THE THORNEY ISLAND SOCIETY

Magistrates Court, 70 Horseferry Road, London SW1P 2AX

Demolition and redevelopment to provide residential units etc as applied to two proposals identified as Scheme ll (classical and Scheme lll (modern)
ref 09/06354/FULL TP/4556:
ref 09/0611/FULL TP/4556

Ref 12/00258/FULL

Horseferry Road - existing and proposed

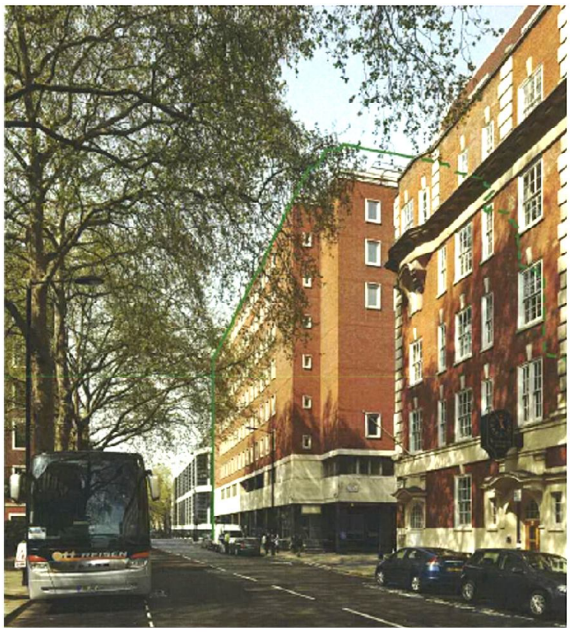
Brick or brick colour is not retained

Proposals look like an office complex
